# Wunder-Bar™

## TECHNICAL SERVICE BULLETIN (REVISED)

Product: All Bar guns – Standard and Flow Regulated

Subject: Possible Leaking Heels Due to Stack Up Tolerance of Barrier Tubing

Area where a leak may occur

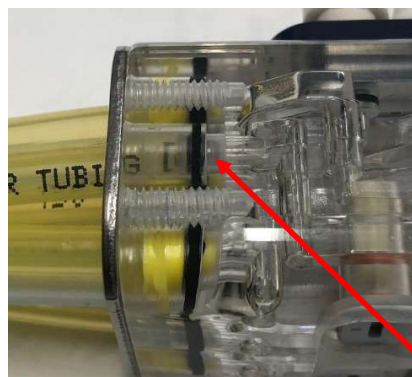
When the barrier tubing is on the low end of the manufacturing tolerance, there is the potential for inadequate compression of the barrier tube cap into the Bar gun handle, which could result in a slow drip.

Handles are now machined where the large barrier tubing holes are shallower in depth to allow for adequate compression where the large barrier tube cap and O-ring meet.

Bar guns with a manufacturing date of 09/17/2019 and older that exhibit a leak should be submitted through the normal RMA process either directly with Wunder-Bar or the distributor you purchased your Bar guns from.
